INNER WEST COUNCIL

DEVELOPMENT ASSESSMENT REPORT

Application No.	DAREV/2017/14
Address	10 Lilyfield Road, ROZELLE NSW 2039
Proposal	Seeking a Review of D/2016/432 for alterations and additions to existing dwelling including ground and first floors and removal of 7 x palm trees. Review includes additions to existing laundry area at rear lower ground level.
Date of Receipt	10 March 2017
Applicant	Brookes Associates Architects
Owner	Mr E G Ngawaka and Mrs J A Ngawaka
Number of Submissions	Two (2) objections
Building Classification	1a
Reason for determination at Planning Panel	Exceeds officer delegation as there is no substantial change to the recommendation of the review.
Main Issues	Heritage/Streetscape
Recommendation	Refusal
Attachment A	Plans of proposal
Attachment B	Draft conditions of consent

Drawing
NORTH AND SOUTH ELEVATIONS
 Client
 JAIME & ELDON NGAWAKA

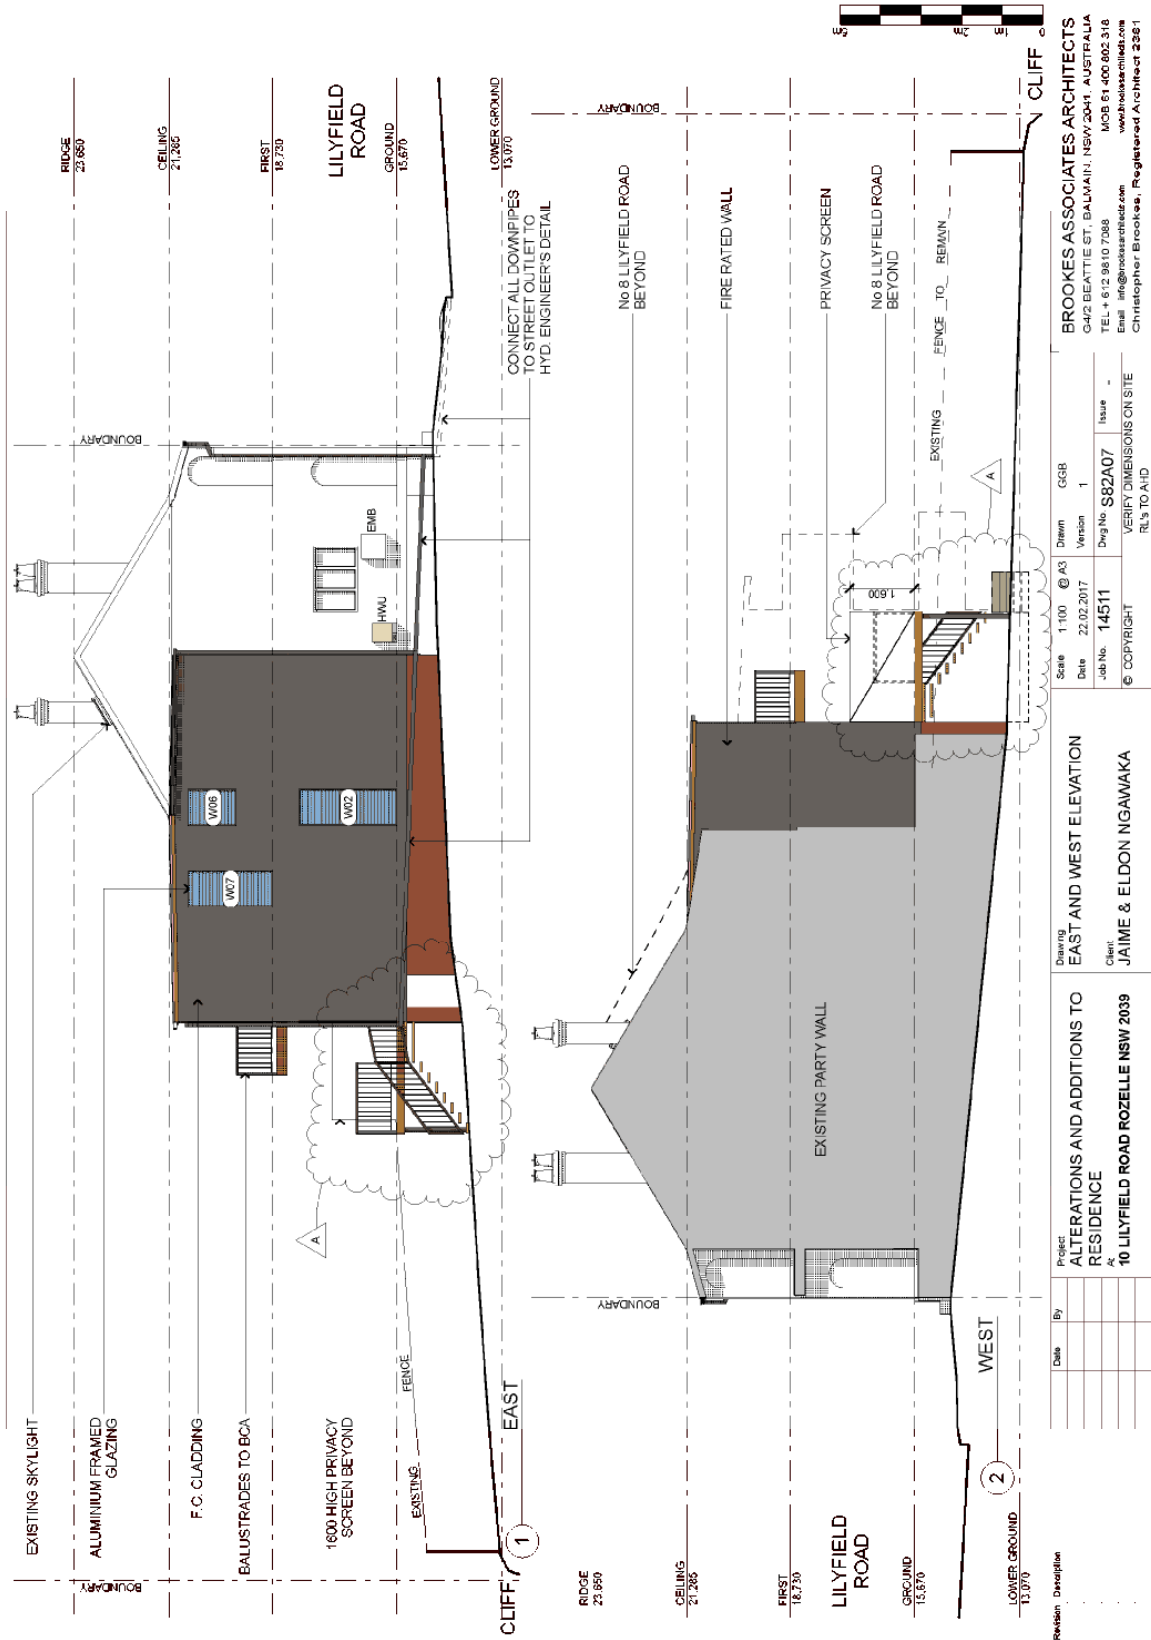
Comment: The proposed alterations to the dwelling, which are visible at the side of the existing building from the street within the conservation area, renders this particular site unsuitable for the form of development proposed.

The proposal will not result in loss of significant views from the rear of 12 Lilyfield Road. The proposed extension to the subject site involving a side wall extending approx. 2.6m beyond the existing rear wall alignment of the dwelling will act to remove some existing limited outlook to the south-east over the adjoining eastern properties toward Rozelle Bay, though no water views exist from No.12. The current outlook from both the lower rear deck and upper rear windows of that property are highly constrained by existing vegetation. Less restricted district views through vegetation exist to the south-west. However, views over the rear of the subject property and No.8 Lilyfield road are limited. (see photos below)

Project: ALTERATIONS AND ADDITIONS TO RESIDENCE AT 10 LILYFIELD ROAD ROZELLE NSW 2039
 Drawing: LOWER GROUND, GROUND & FIRST FLOOR PLANS
 Client: JAIME & ELDON NGAWAKA

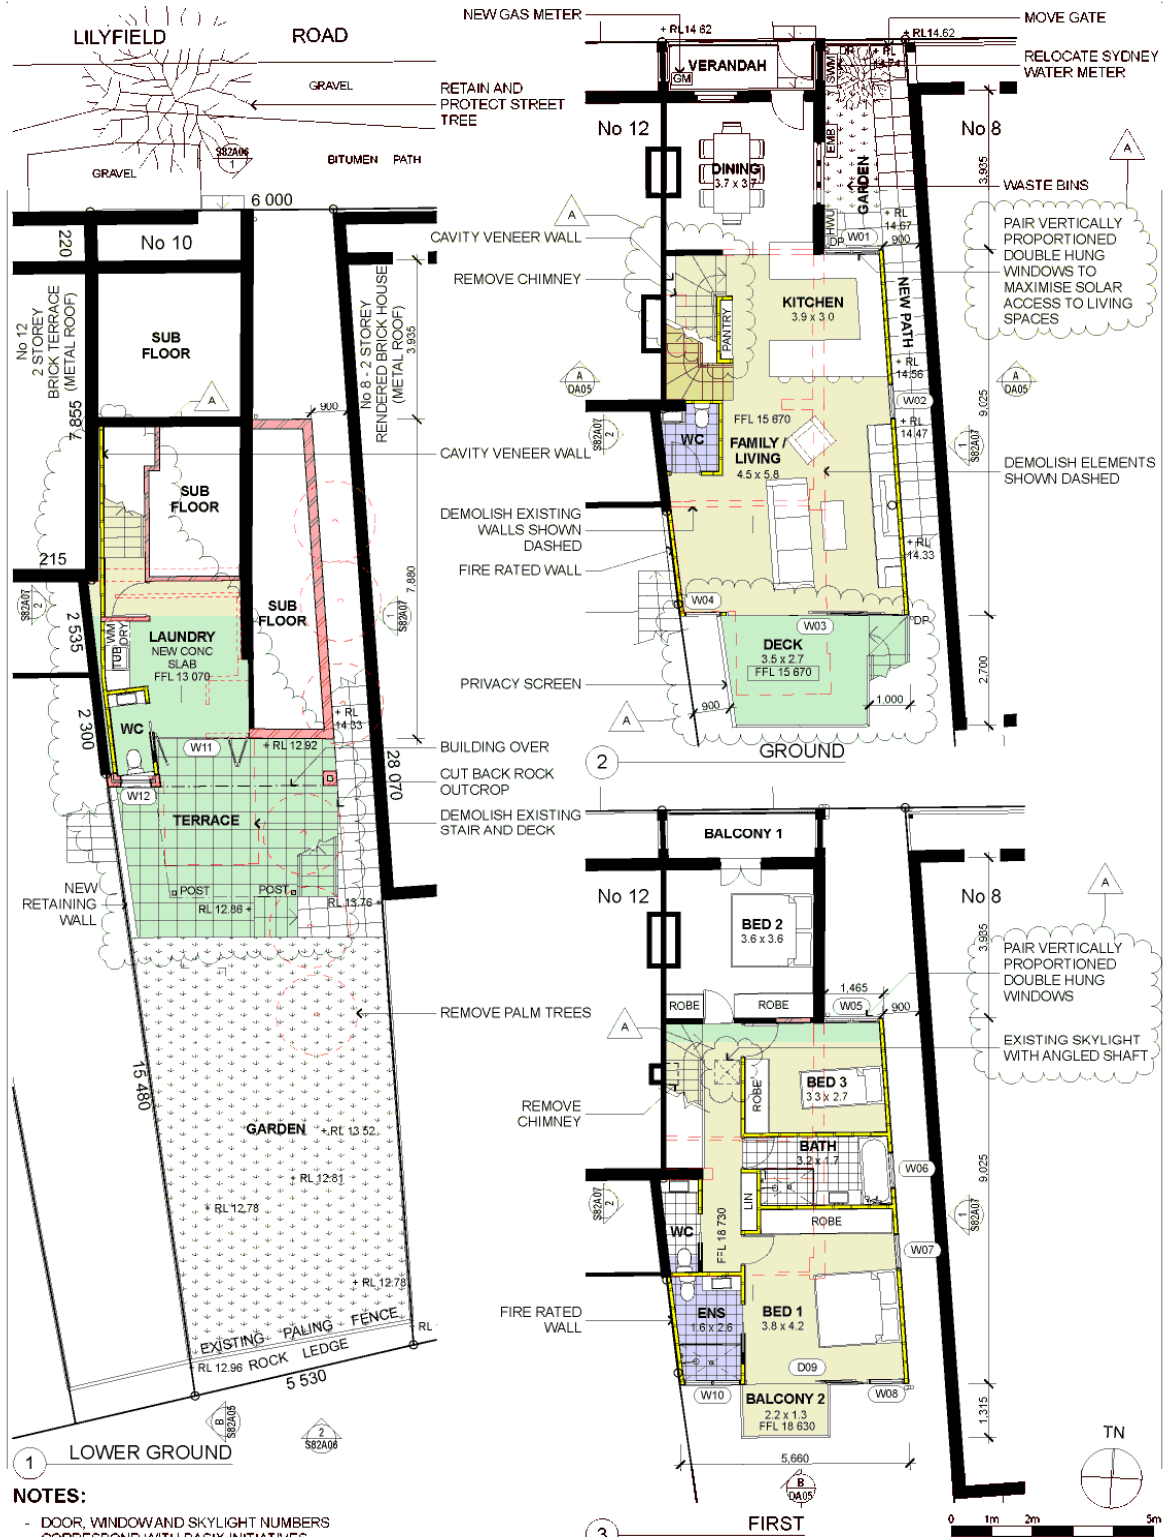
4. The proposal does not provide a compliant minimum 2.4m ceiling height within the rear upper bedroom as required under the Building Code of Australia.
